3. PROJECT DESCRIPTION

This section provides an overview of the Project and provides additional clarification of the Project Description in the EIS in response submissions.

**EMU SWAMP DAM
SUPPLEMENTARY REPORT**

Figure 3-2

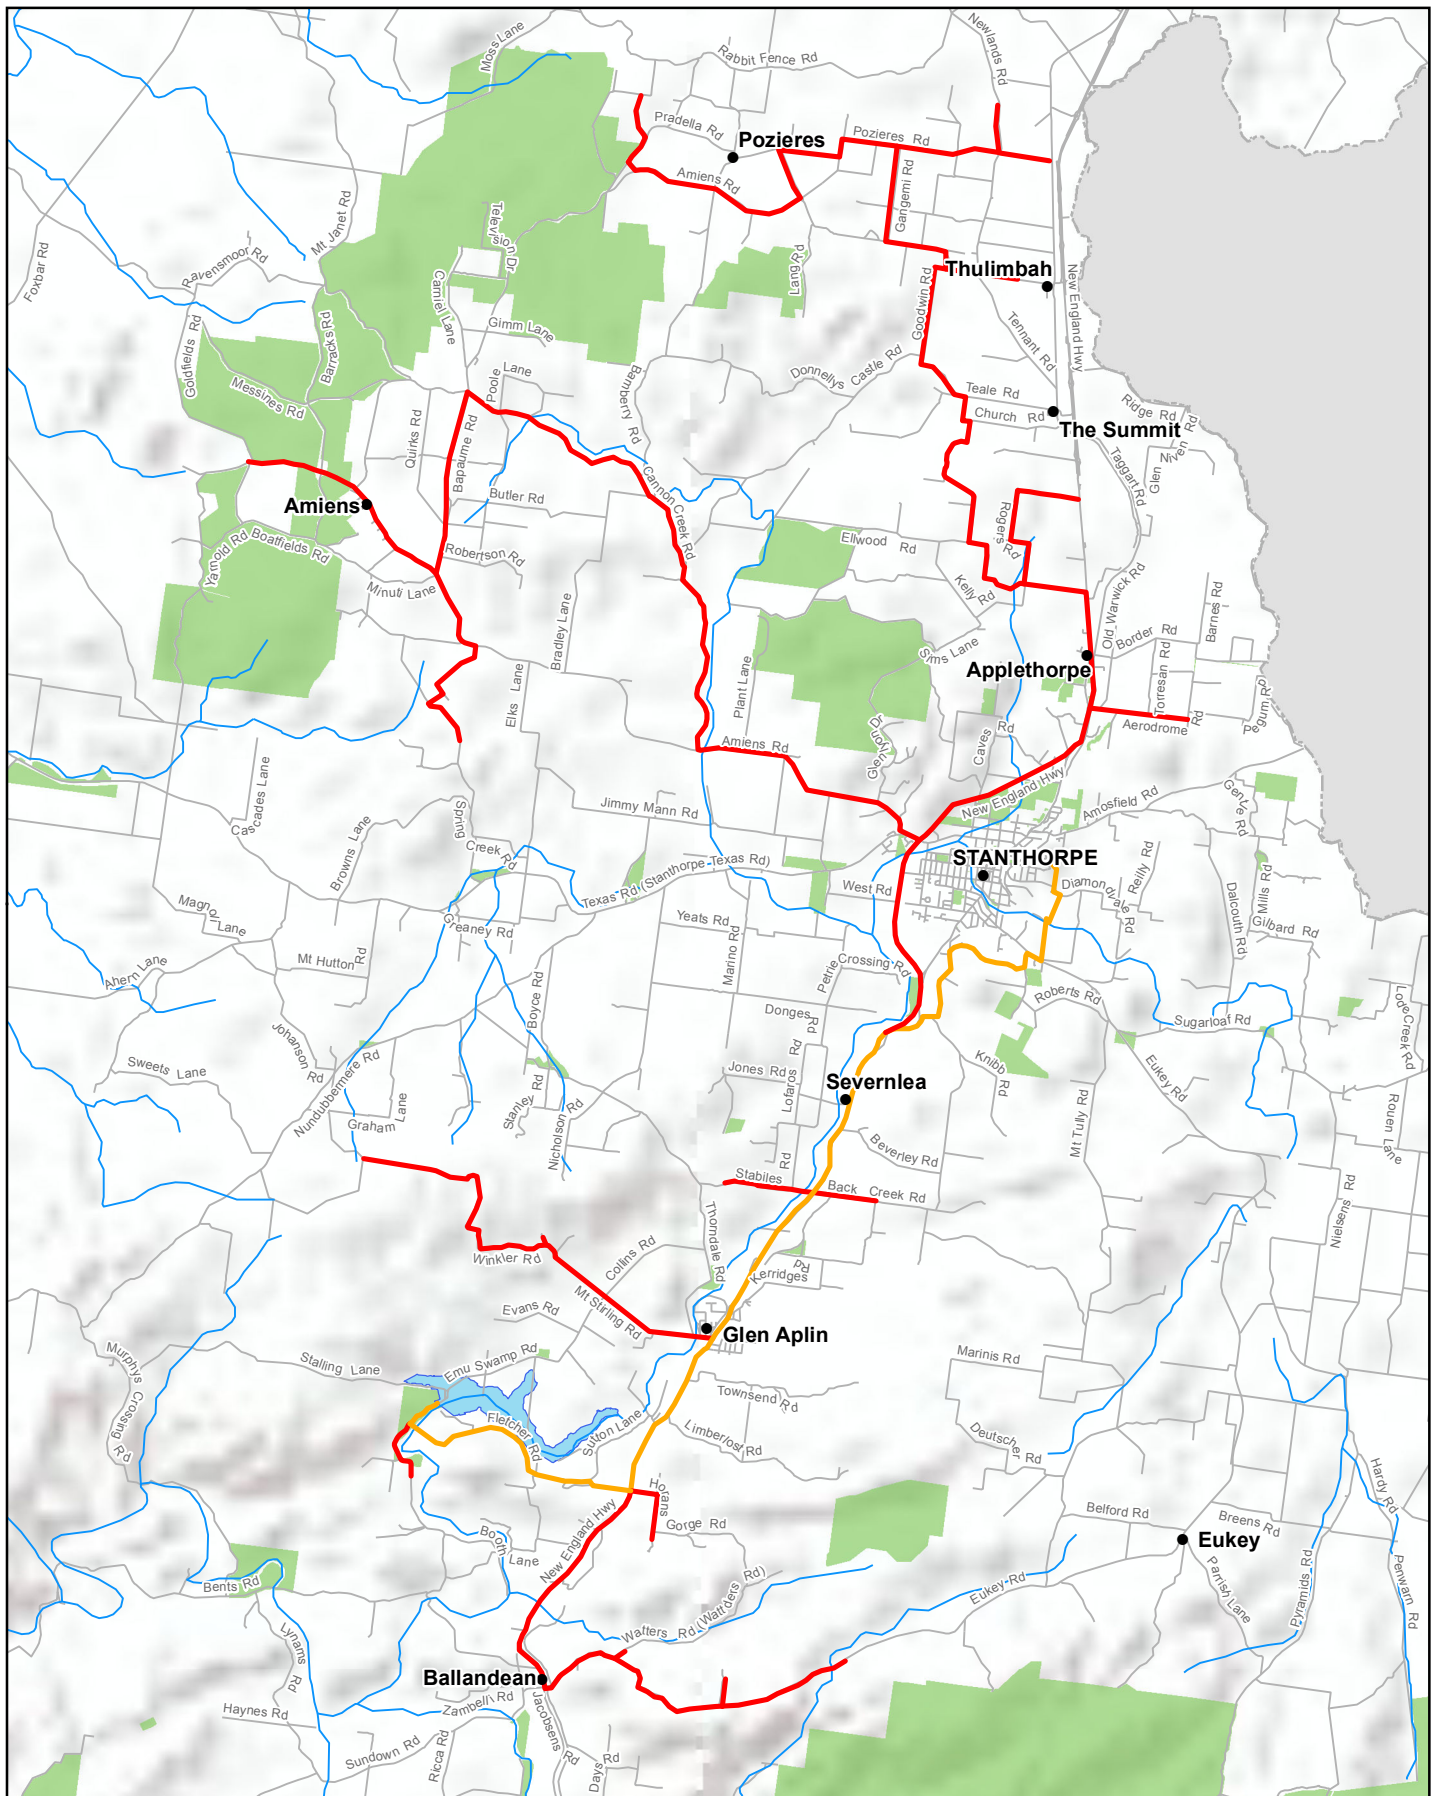
One submission requested information on how the pipeline route was selected. The pipeline route was developed by Stanthorpe Shire Council with reference to the Stanthorpe Community Reference Panel.

A submission has requested that an update of information on the current pipeline route. The pipeline route for the urban and irrigation pipelines have not changed since the EIS. The final alignment of the urban and irrigation pipelines will be confirmed during detailed design. SDRC are committed to minimising the potential environmental impacts associated with the construction of the urban and irrigation pipelines.
